Amdt. to ol/change to Appendix A tech specs  
furnished in exhibits A & B and safety  
evaluation in support of the change furnished  
in exhibit C entitled "License Amendment  
Submittal for Single-Loop Operation".

MONTICELLO NUCLEAR GENERATING PLANT  
Docket No. 50-263 License No. DPR-22

License Amendment Request Dated September 7, 1976

PROPOSED CHANGES TO TECHNICAL SPECIFICATIONS  
APPENDIX A OF PROVISIONAL OPERATING  
LICENSE NO. DPR-22

FIGURE 2.3.1  
APRM FLOW REFERENCED SCRAM AND ROD BLOCK TRIP SETTINGS

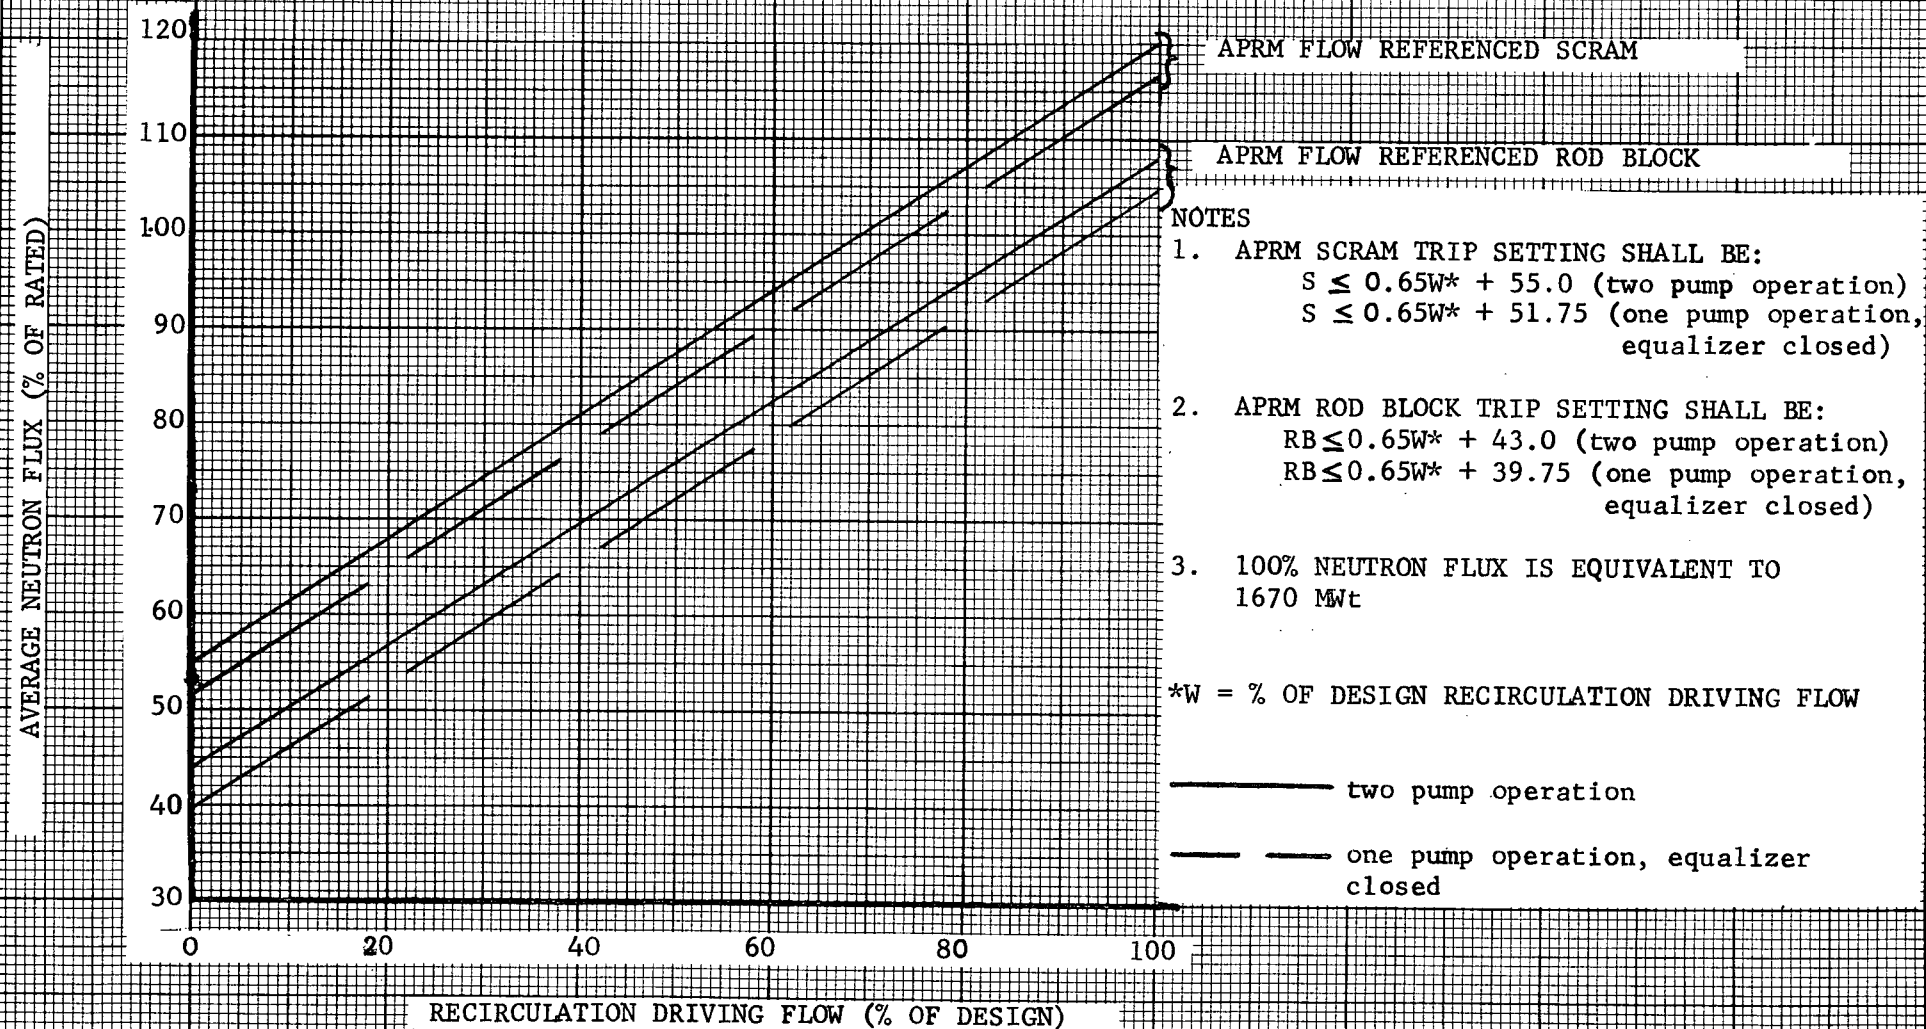
Operation with one recirculation pump and the equalizer line closed causes flow to bypass the core through idle jet pumps. This loss of core flow is accounted for in the specified setting adjustments for the one-pump, equalizer closed case. Reference the September 7, 1976 License Amendment Request from L O Mayer (NSP) to Victor Stello (USNRC).

The operator will set the APRM neutron flux trip setting no greater than that shown in Figure 2.3.1. However, the actual setpoint can be as much as 3% greater than that shown on Figure 2.3.1 for recirculation driving flows less than 50% of design and 2% greater than that shown for recirculation driving flows greater than 50% of design due to the deviations discussed on page 18.
